# UNITED STATES PATENT AND TRADEMARK OFFICE

10/561,649

<b>Office Action Summary</b>	<b>Application No.</b> 10/561,649	<b>Applicant(s)</b> ABEL ET AL.	
	<b>Examiner</b> LINDSEY BACHMAN	<b>Art Unit</b> 3734

## **DETAILED ACTION**

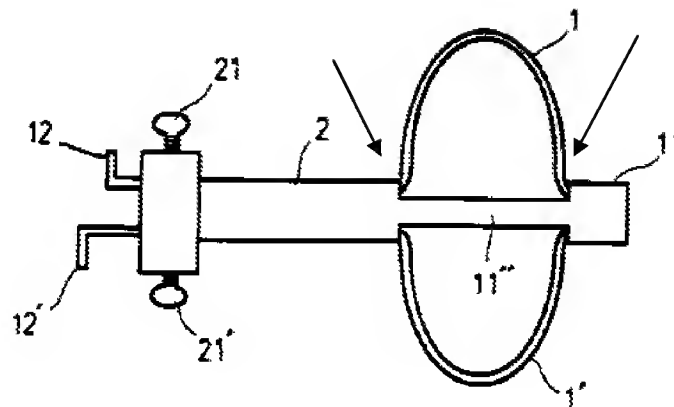
Claim 1, 3, 4, 5, 21, 22, 23, 26: Shaw’572 discloses a medical apparatus having a guide member (2) with a leading end (11) and an aperture (see Figure 4b, area between 1 and 1’) defining an area for access from the apparatus into a body passage. The area is spaced from the leading end (see Figure 4b). The apparatus is controllably movable between a collapse position (Figure 4a) and an expansion position (Figure 4b) by controllably elastically deforming expansion arms (1, 1’). The arms extend across edge regions of the aperture (arrows in the copy of Figure 4b below identify Examiner’s interpretation of edge regions).

Claim 14: Shaw'572 discloses the access area extends from the leading end and part way along a length of the apparatus (see Figure 4b).

Claim 20: Shaw'572 discloses the access area extends around the entirety of the device except for the guide member, which is shown to be less than half of the perimeter of the device (Figure 4b).
